**METROPOLITAN GOVERNMENT OF NASHVILLE AND DAVIDSON COUNTY**

**STAFF RECOMMENDATION**  
**229 Cherokee Road**  
**December 18, 2013**

**Application:** Partial demolition; New construction--addition  
**District:** Cherokee Park Neighborhood Conservation Zoning Overlay  
**Council District:** 24  
**Map and Parcel Number:** 10312001500  
**Applicant:** Randy Robinson  
**Project Lead:** Melissa Baldock, melissa.baldock@nashville.gov

<p><b>Description of Project:</b> Application is to construct a side addition, a rear addition that is wider than the house, and a new front porch.</p> <p><b>Recommendation Summary:</b> Staff recommends approval of the project with the following conditions:</p> <ol style="list-style-type: none"> <li>1. Staff approve the windows and doors, the porch column materials, and the roofing colors;</li> <li>2. The HVAC be located on the rear façade, or on a side façade beyond the midpoint of the house.</li> </ol> <p>With these conditions, staff finds that the project meets Section II.B.1. and II.B.2. of the <i>Cherokee Park Neighborhood Conservation Zoning Overlay: Handbook &amp; Design Guidelines</i>.</p>	<p><b>Attachments</b>  <b>A:</b> Photographs  <b>B:</b

Left side facade

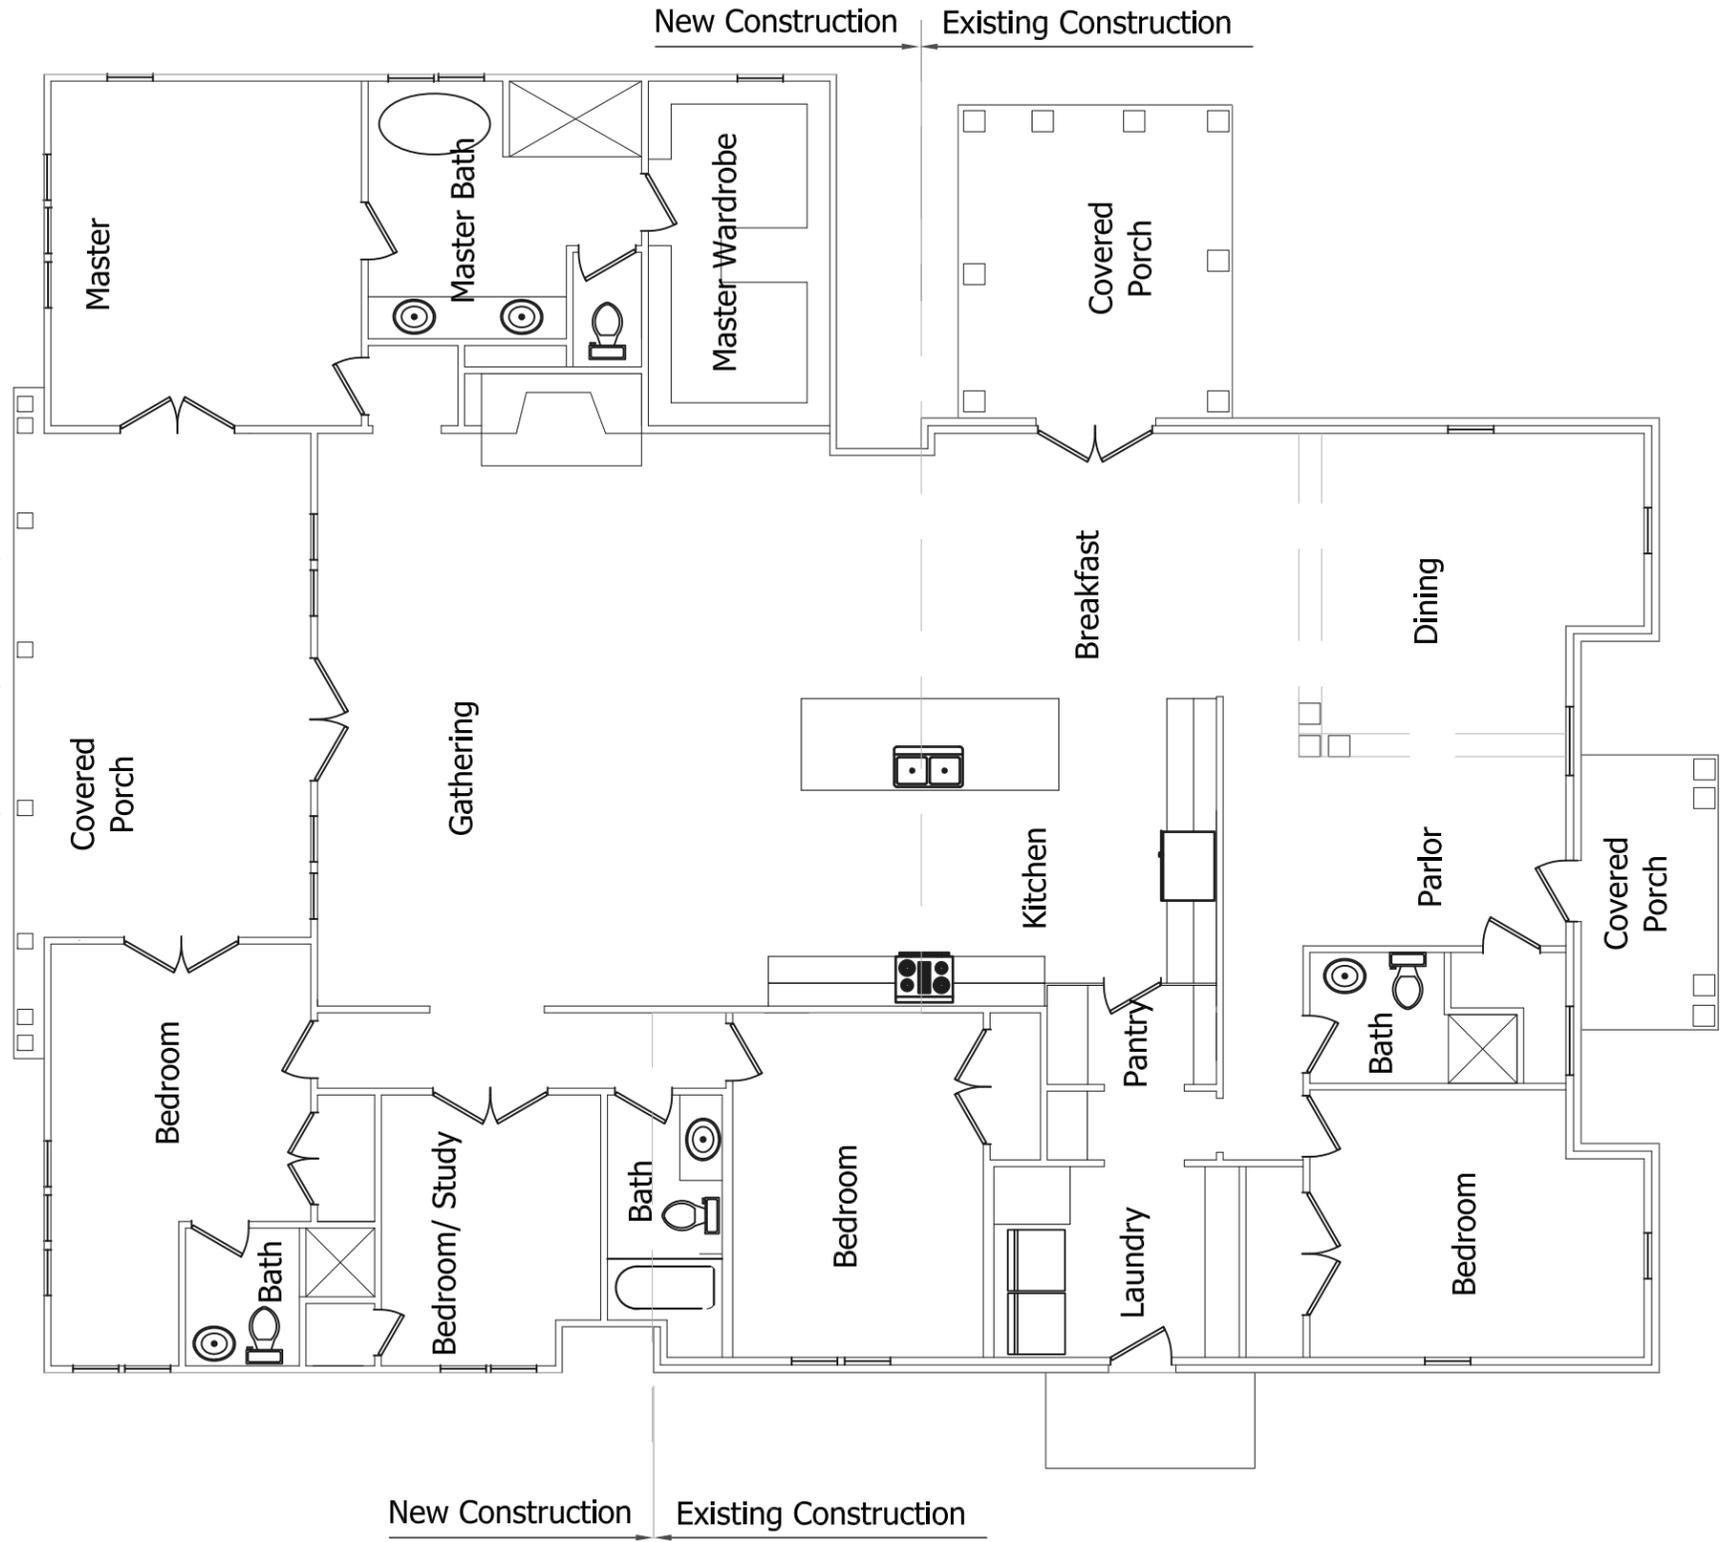
Proportion and Rhythm of Openings: The project does include some alterations to the existing window and door pattern. On the right side, two window openings on the back half of the house will be removed, and the doorway will be relocated to provide entry from the new side porch. On the left façade, the side entry door will be shifted approximately three feet (3') to the left, and three separate windows on the back half of the house will be replaced with a paired window opening. Staff finds the alterations to

Sheet: **A5.01**

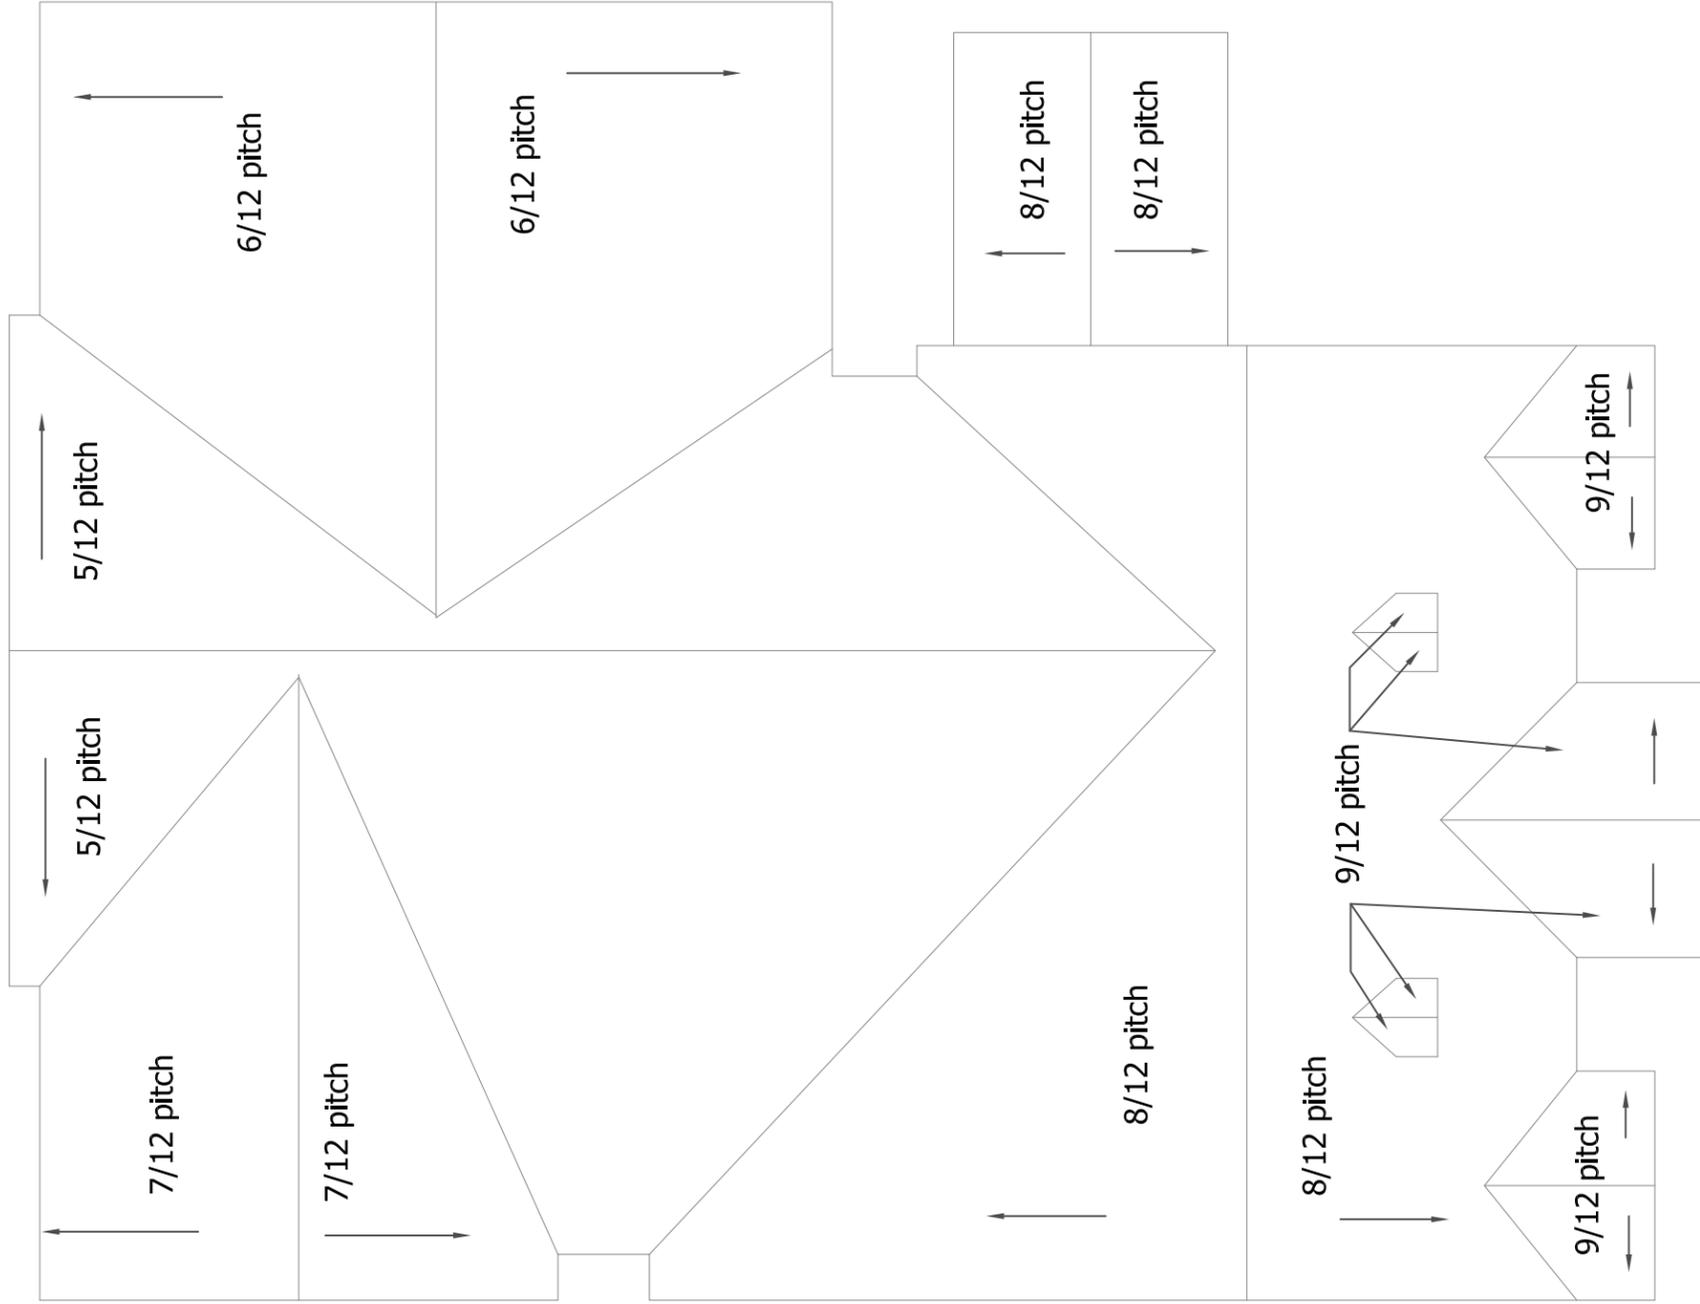
Roof form: The existing house has a side gable roof form with a slope of 8/12. The front façade has two projecting gables with a slope of 9/12. The new front porch roof will also be a gable with a slope of 9/12 to match the projecting bays. The side addition will have a side gable form with a slope of 8/12 to match the historic house's roof form. The rear addition has a side gable form with a slope of 6/12. Staff finds that the projects roof forms meet section II.B.1.e. of the *Cherokee Park Neighborhood Conservation Zoning Overlay: Handbook & Design Guidelines*

Sheet: **A3.01**

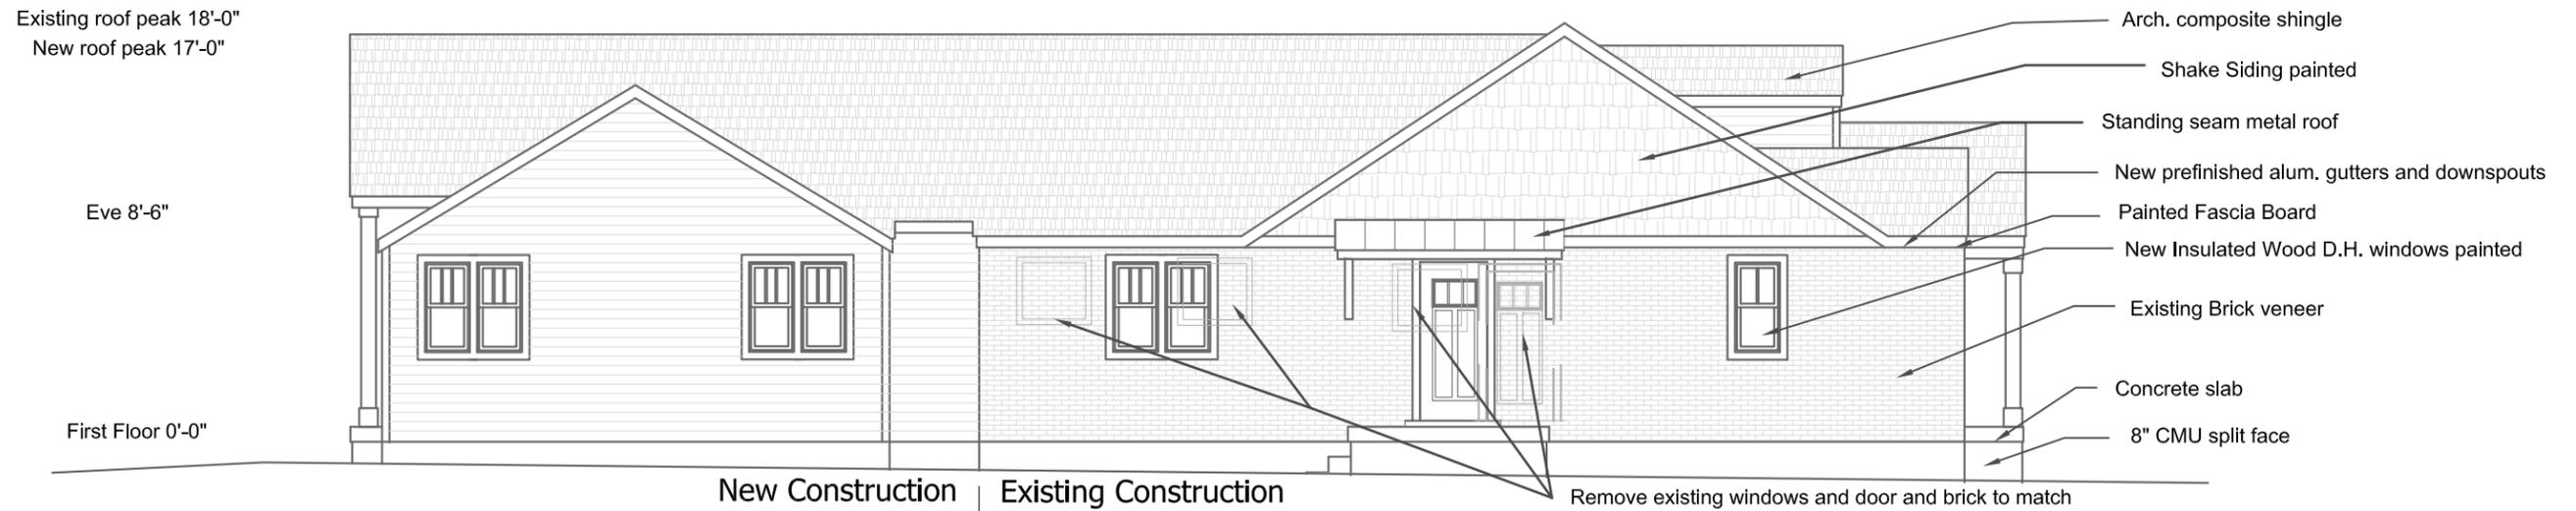
Height & Scale: The rear addition will be one story tall and will be one foot (1') shorter than the historic house. It will be approximately nineteen feet, nine inches (19'9") tall above grade. Its foundation height and its eave height will match the foundation and eave height of the historic house. The one story side porch will be significantly shorter than the historic house; it will have an eave height of approximately nine feet, three inches (9'3") and a ridge height of fourteen feet, six inches (14'6").

1. Staff approve the windows and doors, the porch column materials, and the roofing colors;
2. The HVAC be located on the rear façade, or on a side façade beyond the midpoint of the house.

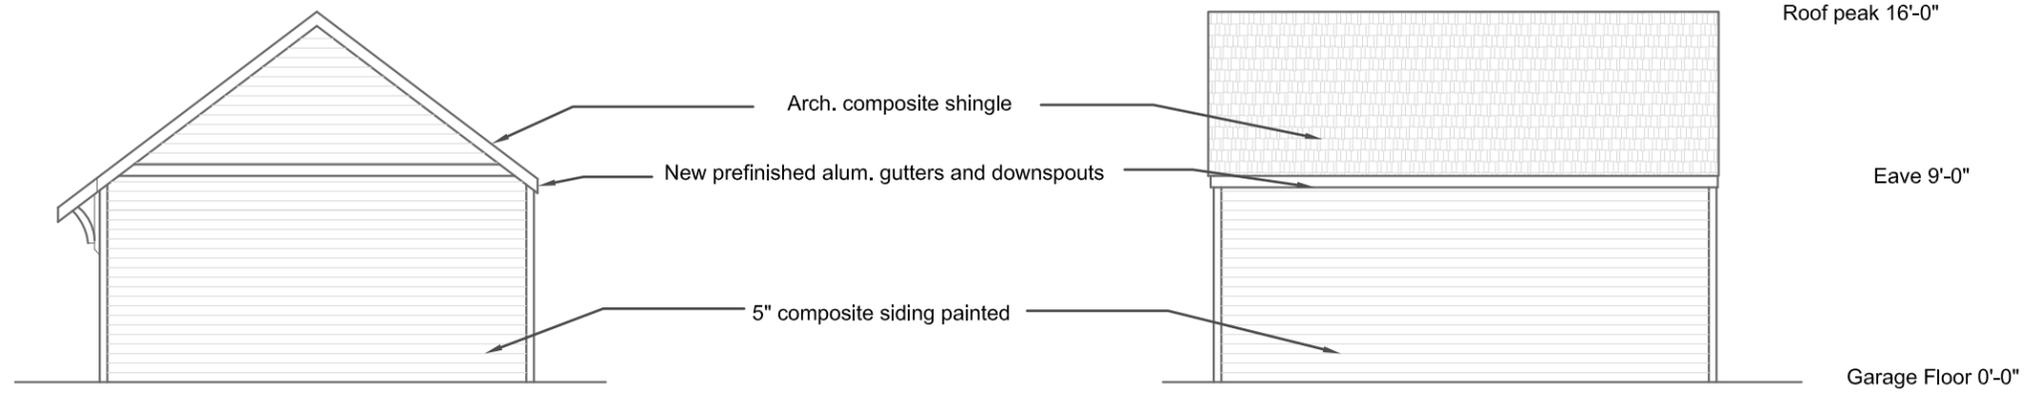
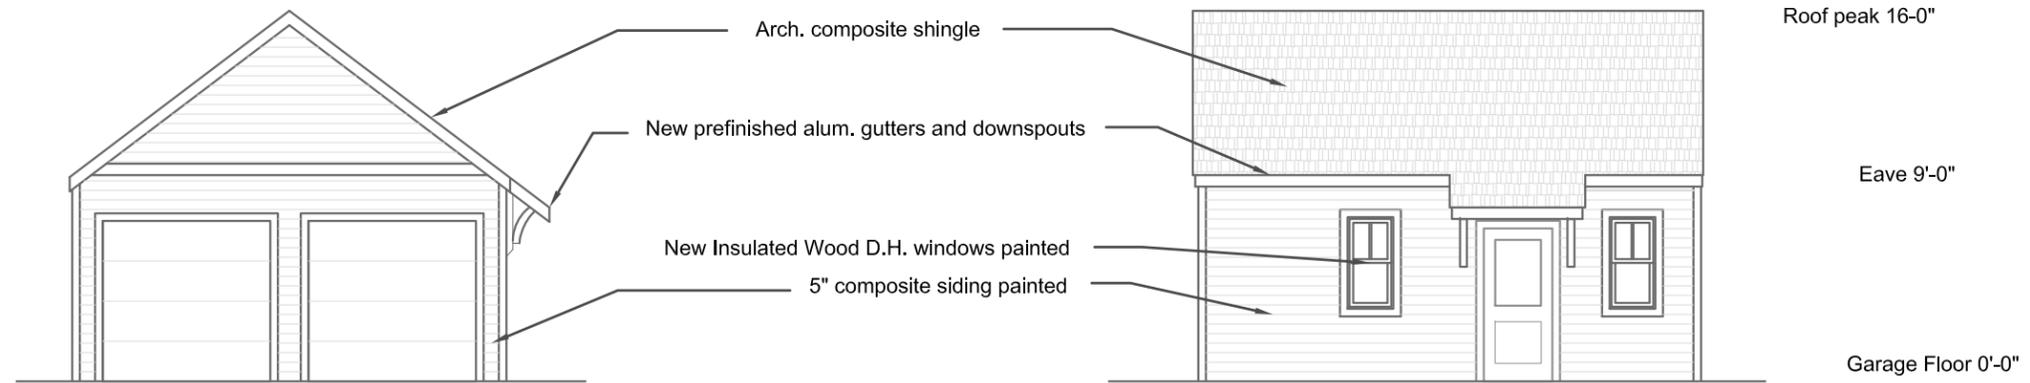
The rear addition steps in from each of the back corners of the house. It steps in one foot (1') the right side and two feet (2') on the left side. On the left side, after a depth of approximately four feet (4'), the addition steps back out to line up with the historic house. On the right side, after a depth of four feet (4'), the addition steps back out and extends fifteen feet, six inches (15'6") wider than the historic house. Staff finds the wider addition to meet the design guidelines because the lot is so wide and because the addition does not become wider until after an appropriate inset. In addition, the addition allows for the retention of the back corner of the house.

<b>ROBINSON CONSTRUCTION</b> robinsongroup@comcast.net 615-300-4294	Project: <b>229 CHEROKEE ROAD</b>	Date: <b>11/26/13</b>	Scale: <b>1/8" = 1'-0"</b>	Sheet: <b>A6.01</b>
--	-----------------------------------	-----------------------	----------------------------	---------------------

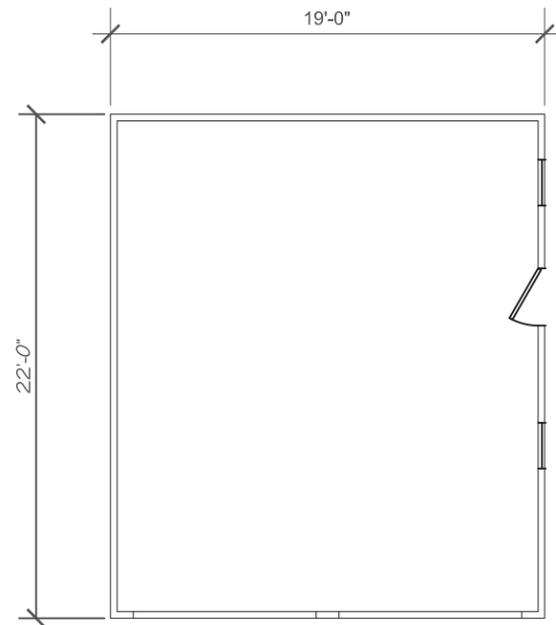
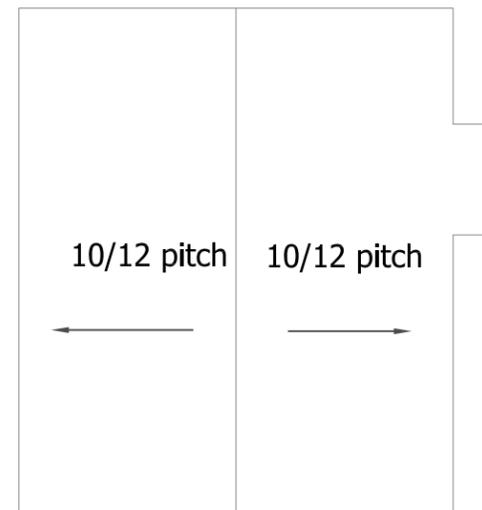
Outbuildings: A one-story outbuilding is proposed. The outbuilding will be located at the back left corner of the lot and will meet all base zoning setbacks. It will be three feet (3') from the left side property line, and five feet (5') from the rear property line. The garage will be accessed via an existing curb cut and driveway.

The garage will be subordinate to the historic structure. It will be nineteen feet by twenty-two feet (19' X 22'), and will have an eave height of nine feet (9') and a ridge height of sixteen feet (16'). It will have front-facing gable with a slope of 9/12. The materials will be similar to those proposed for the addition, and include five inch (5") cement fiberboard siding, wood windows, and architectural composite shingles. The proportion and rhythm of openings are appropriate for an outbuilding; the garage will have two separate garage bays facing Cherokee Road. Staff finds that the outbuilding meets section II.B.1.h of the *Cherokee Park Neighborhood Conservation Zoning Overlay: Handbook & Design Guidelines*.
